To: Planning Committee **Date:** March 11, 2008
From: Brian J. Jackson **File:** RZ 07-369284
Director of Development
Re: **Application by Raman Kooner for Rezoning at 11311 Williams Road from Single-Family Housing District, Subdivision Area E (R1/E) to Single-Family Housing District (R1-0.6)**

Project: **Proposed 2 lot subdivision – 11311 Williams Road Richmond
RZ 07-369284**

Re: **Tree Retention Assessment**

**BRITISH COLUMBIA LAND SURVEYOR'S CERTIFICATE SHOWING EXISTING TREES ON LOT 3 BLOCK 2 SECTION 25 B4N R6W
NEW WESTMINSTER DISTRICT PLAN 18935.**

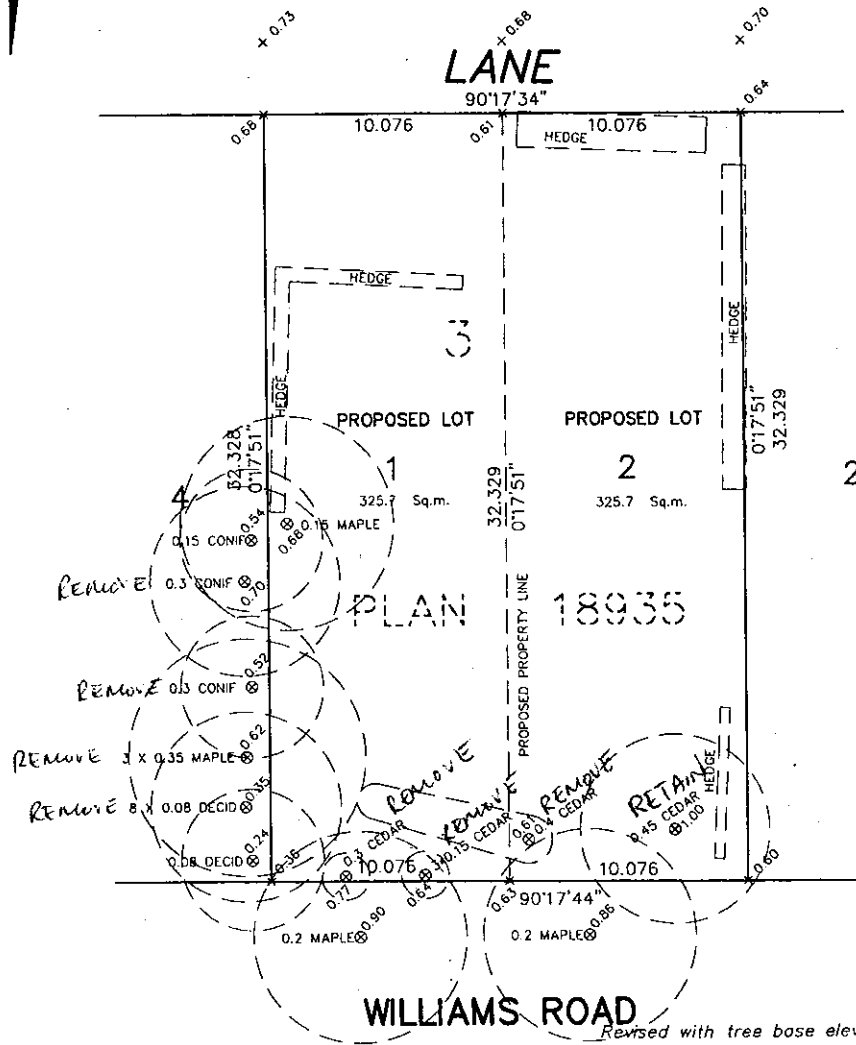
A Tree Survey (**Attachment 3**) submitted by the applicant indicates the location of 13 trees:

- four (4) bylaw-sized trees and one (1) undersized tree on the subject property;
- four (4) bylaw-sized trees and two (2) undersized trees on the adjacent property to the west (11291 Williams Road); and
- two (2) bylaw-sized street trees on City property fronting Williams Road.

A Certified Arborist's report has been submitted by the applicant in support of the application. The report recommends removal of three (3) bylaw-sized trees on-site and retention of the Sequoia tree at the southeast corner of the site. The City's Tree Preservation Coordinator has reviewed and concurred with the Arborist's recommendations for tree removal on the basis of tree condition and conflict with proposed development plans. Based on the 2:1 tree replacement ratio goal stated in the Official Community Plan (OCP), and the size requirements for replacement trees in the Tree Protection Bylaw No. 8057, six (6) replacement trees with the following minimum calliper sizes are required:

Staff also agree that the Sequoia tree should be retained. However, the future dwelling on the eastern lot must be setback 8 m from the front property line to provide additional space for tree and root growth unless the mitigation measures proposed by the Arborist as listed in the Arborist Report Addendum dated Jan 31, 2008 (**Attachment 4**) be implemented. In addition, staff recommend that the Sequoia tree be pruned by a professional arborist for clearance issues and that use of sand-based pavers instead of concrete for any walkways or paths within the front yard of the eastern lot. Installation of retaining walls and perimeter drainage should be hand-dug or installed outside of the tree protection zone. The drainage connection to the eastern lot should be relocated to the western edge of the eastern lot.

As a condition of rezoning, a Restrictive Covenant for Tree Protection must be registered on title in order to preserve the Sequoia tree. The Restrictive Covenant will include language to ensure all structures on the future eastern lot are setback 8.0 m from the front property line. The Restrictive Covenant will also include language to allow the front yard setback, including all projections, be reduced to 6.0 m provided that the mitigation measures to prevent root growth beneath the future structures as listed in the Arborist Report Addendum dated Jan 31, 2008 (**Attachment 4**) are implemented. The applicant will provide a security of \$2,000 for tree survival to be held by the City until one (1) year after the Final Building Permit Inspection is undertaken.

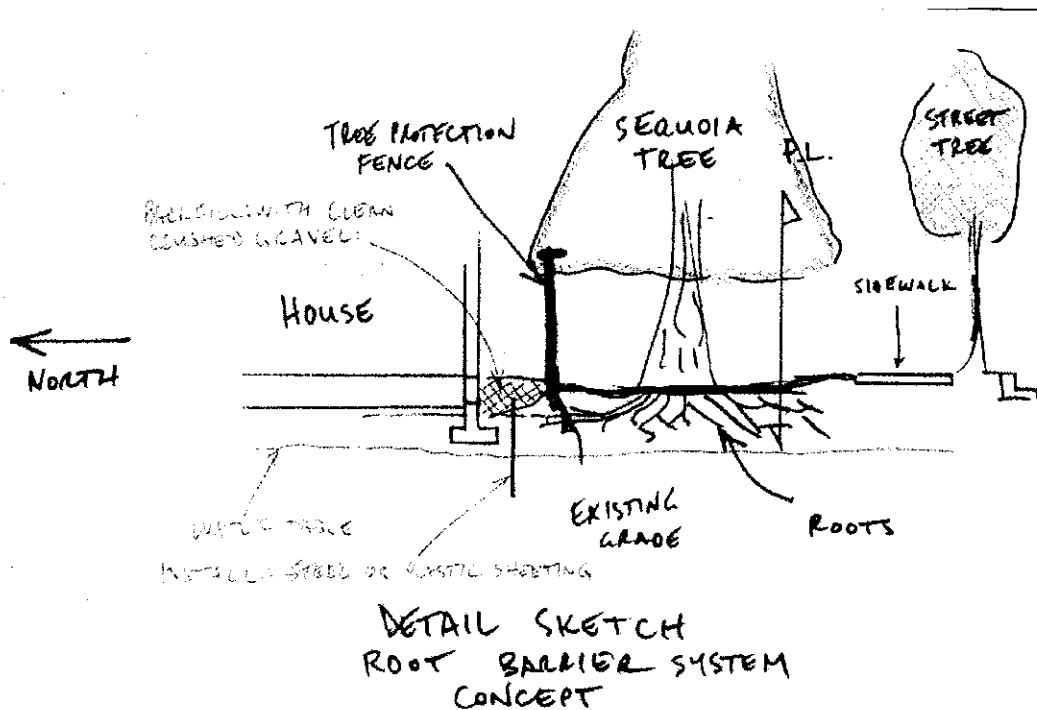
I have received comments from the City review of the Tree Retention Assessment report dated December 19 2007. Further assessment and details are provided below at your request. I reference the points as numbered in the email from Edwin Lee (City) dated January 9 2008. Please forward the revised Tree Retention Plan along with this memo to the City for their records.

2. The protection zone for the Sequoia tree # 536 is a no-access zone as described in the tree protection guidelines on the Tree Retention Plan. Note that a follow-up visit has resulted in a revision to the protection zone to allow sufficient space for underground service connections to be installed on the west side of lot 2 without being in conflict. No retaining walls or perimeter drain can be installed within the tree protection zone.

3. The Sequoia tree dripline is currently 3.5m radius as measured in our field inspection. The tree will eventually grow to have an estimated dripline of 8.0m radius in 30 years. That dripline is shown on the plan for context.

4. The future growth of the Sequoia tree will result in branches growing up to and over a new home constructed to the front yard setback (i.e. 6.0m). This growth can be managed by performing pruning from time to time. The upper foliage that may eventually overhang the house must be left intact, recognizing that additional building maintenance will be required, such as cleaning gutters more regularly than otherwise. All future pruning should be undertaken by a qualified and experienced arborist, certified through the International Society of Arboriculture. The front sidewalk should indeed be constructed using unit pavers instead of concrete so that the future uneven lifting can be easily corrected without hard surface damage and without injuring the roots. The best option would be to provide additional space for tree and root growth on lot 2. For instance, implementing a front yard setback of 8.0m rather than 6.0m will provide relief from encroachments of limbs and roots toward the building. This is not possible without significant detrimental design impacts to the new home.

For best efficacy to minimize root growth too close to the foundation, I recommend an alternative solution as per the detail below. This method will prevent root growth beneath the barrier by penetrating below the water table, and reduce root growth in the upper stratum by keeping the area inert. The house can be built to otherwise normal standards of construction, to the 6.0m front yard setback without long term impacts.
